LOUISIANA
POWER & LIGHT

May 10, 1984

SUBJECT: Waterford SES Unit 3
Docket No. 50-382
Updated Drawings for Emergency Feedwater Actuation System

LOUISIANA POWER & LIGHT CO.
WATERFORD S.E.S. UNIT No.3
CONTROL WIRING DIAGRAM
SG NO2 EMERG FW ISOLATION VA
2FW-V850B

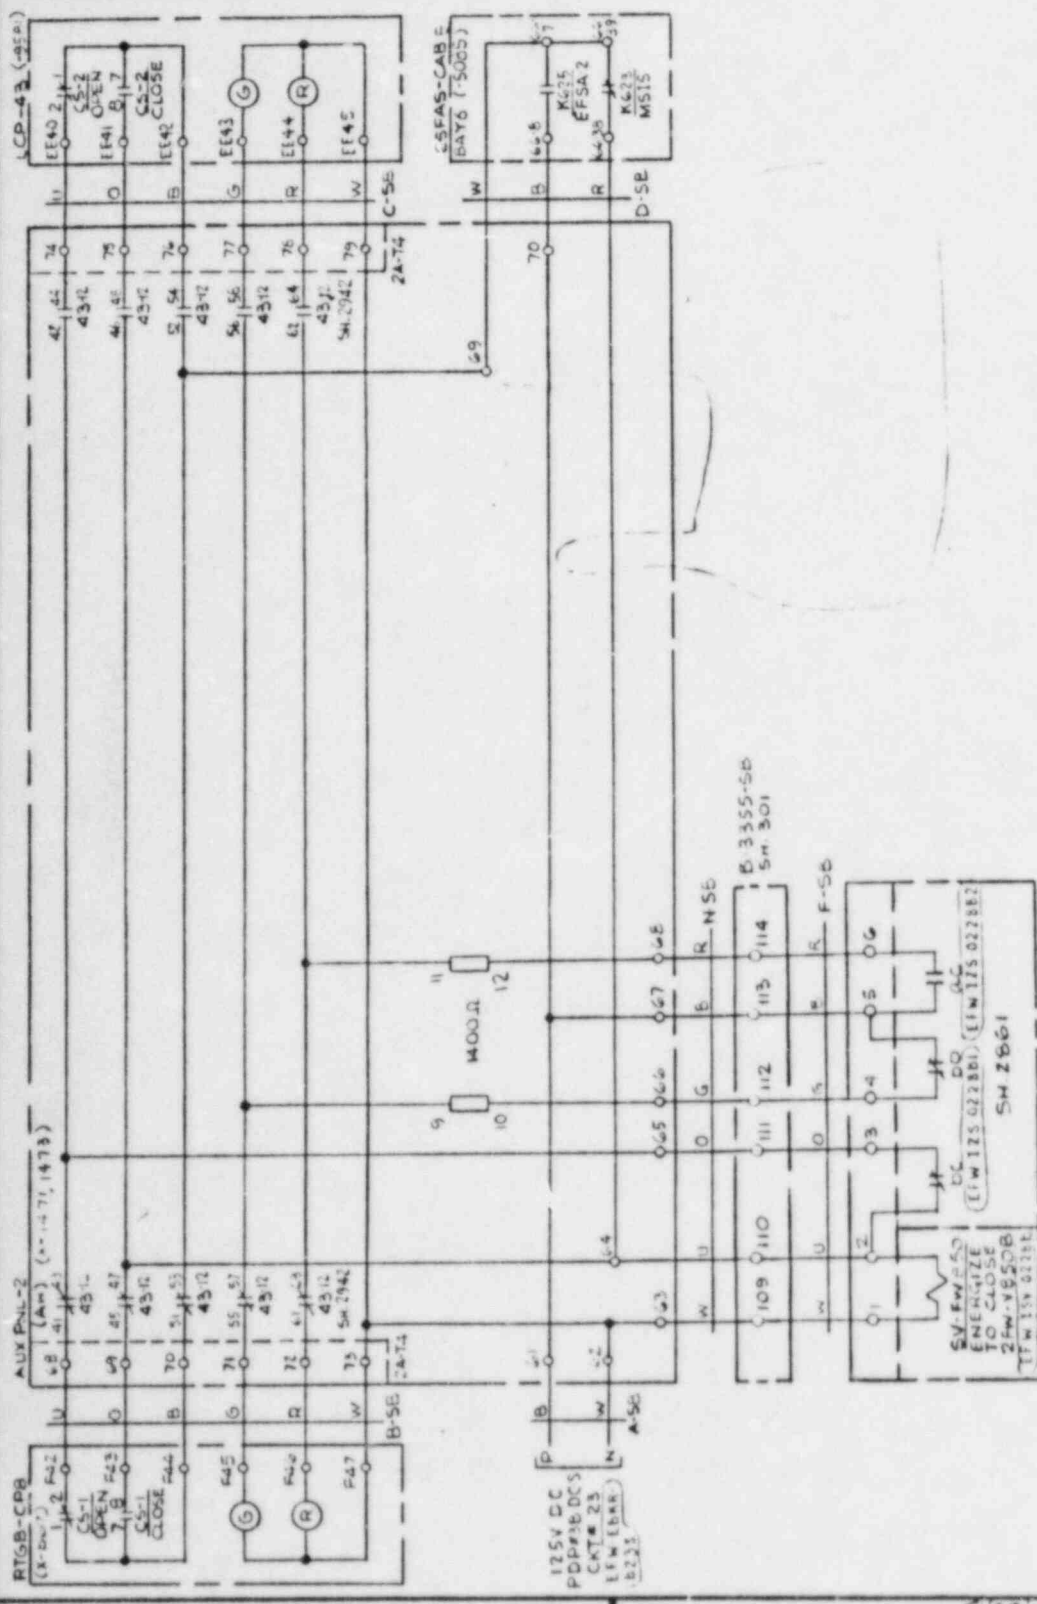
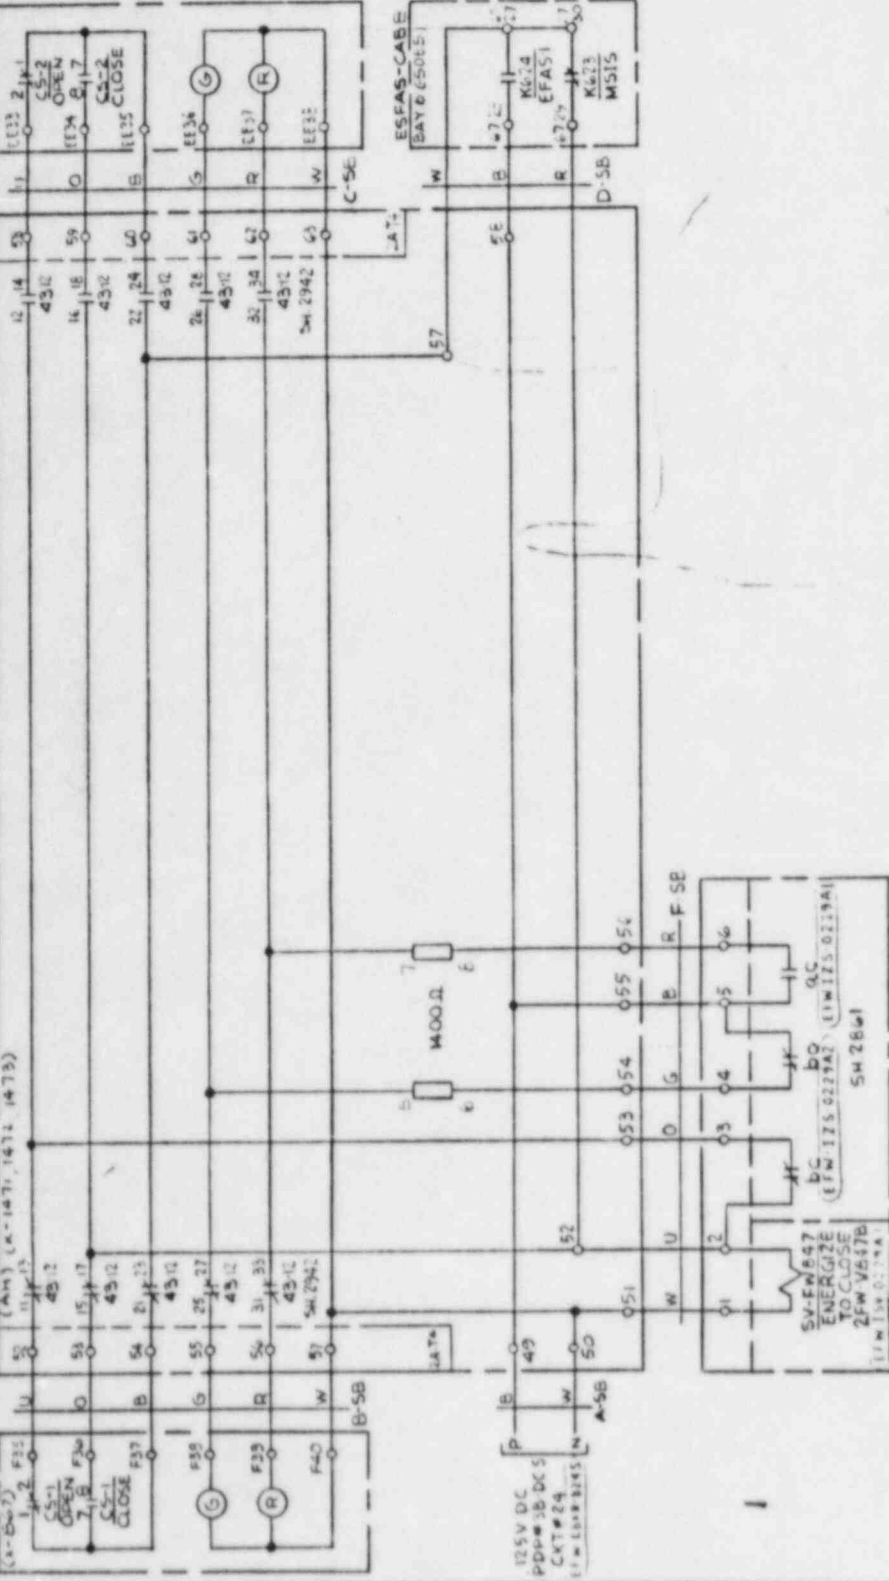
As requested LP&L is pleased to provide updated Control Wiring Diagrams (CWD) pertaining to the Waterford 3 Emergency Feedwater Actuation System (EFAS). These drawings were provided unofficially and reviewed during a meeting held on April 26, 1984 between LP&L and members of your staff. These drawings indicate the removal of level contacts, at the PAC panels, for the Emergency Feedwater Isolation valves.
